**Sandy Hook Permanent Memorial Commission
Newtown Municipal Center, Council Chamber
3 Primrose Street, Newtown, CT**

SD Revision Study

Sandy Hook Permanent Memorial

Schematic Revision Option 1

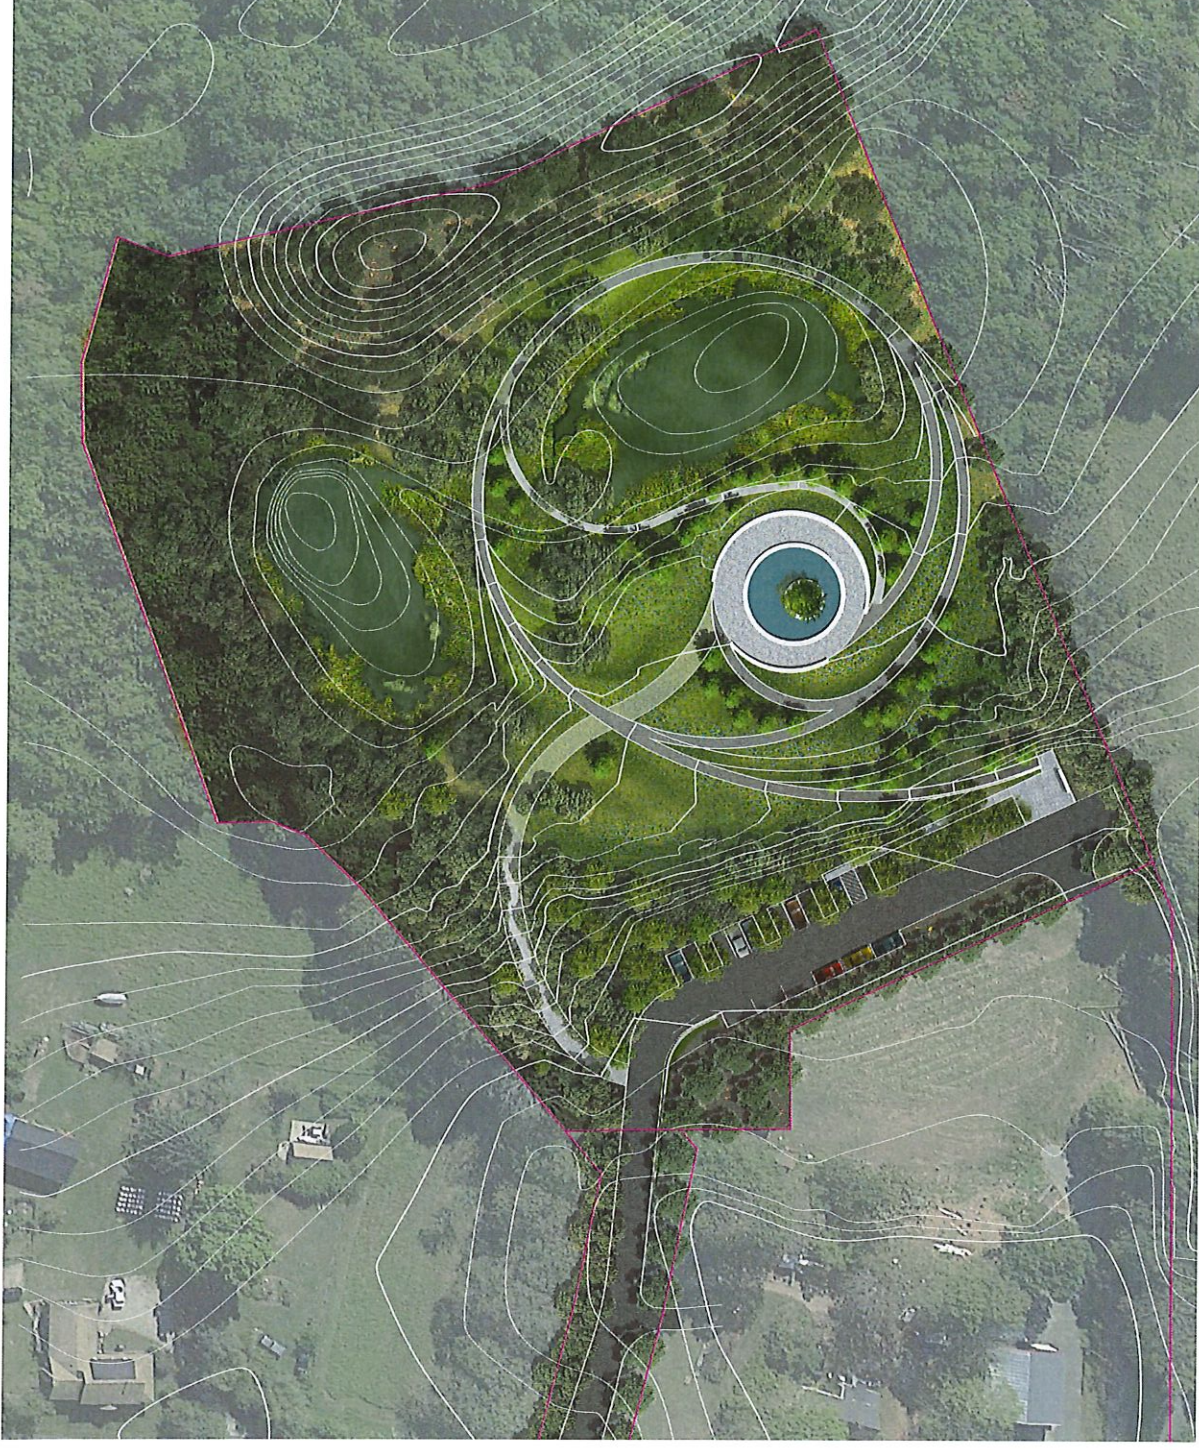
A. Martin believes there are elements to keep as well as forgo. He thinks keeping a bridge is important to the entire project and wants to know the cost of proposed reductions.

T. Pinto noted that none of the three options have a bridge over the water and questioned if it was feasible.

J. Bacon feels the three options are not what was voted on. The water feature is intact but the intricate walk ways, which were symbolic, are non-existent. The option without the bridge doesn't have the impact and she feels the design has been reduced too much. There was discussion on the pavilion, possibly removing that and restoring a bridge. J. Bacon also inquired on the savings involved in having cheaper security fencing. Additionally, she asked if anyone has reached out to local resources.

- Remove Bridges
- Switch from NaturalPave to Asphalt
- Reduced Pond Treatment
- Reduced Path Network
- Reduced Planting
- Remove Benches
- Grading Reduction
- Reduced planting/irrigation
- Simplified lighting plan
